INTRODUCTION

OUTLINE OF NEW FEATURES

The following changes have been made to the 2013 model year.

4. Rear View Mirror

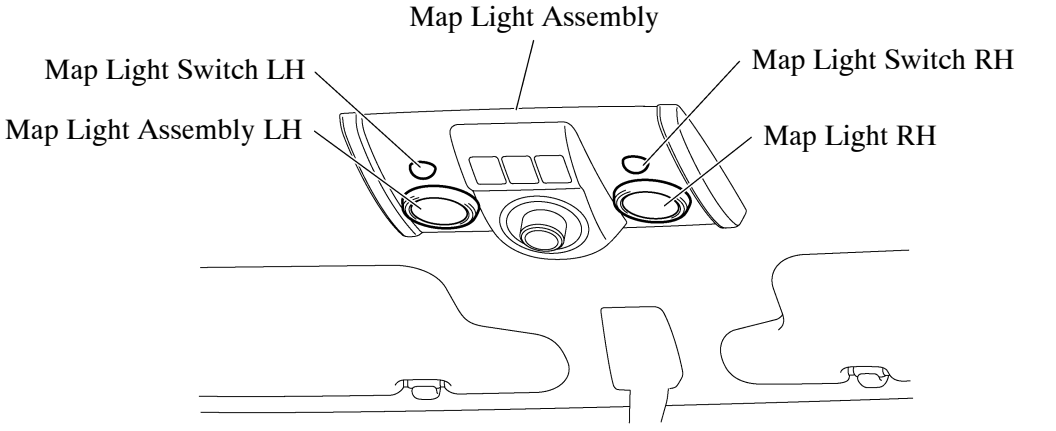
- The display size for the rear view monitor has been changed to 3.3 inches.
- The inner rear view mirror assembly, which consists of the EC mirror, rear view monitor system display unit and the garage door opener, has been provided. For details, see page 25.

▶ Specifications ◀

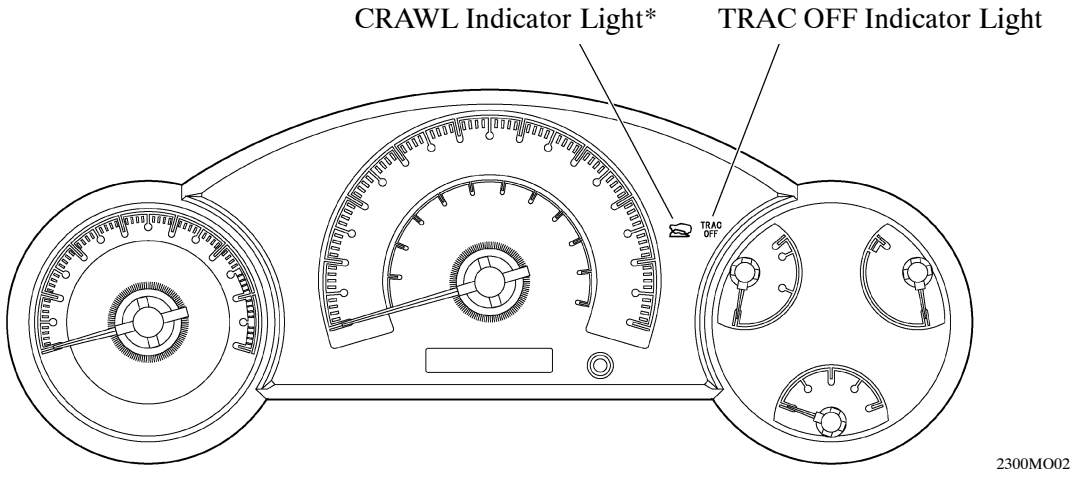
- A DRL OFF position to turn off the daytime running light system has been added to the light control switch on models with the daytime running light system except for optional destination package models for Canada.
- A map light assembly which integrates with a CRAWL control switch assembly, transfer position switch, and differential lock switch has been adopted in vehicles equipped with CRAWL.
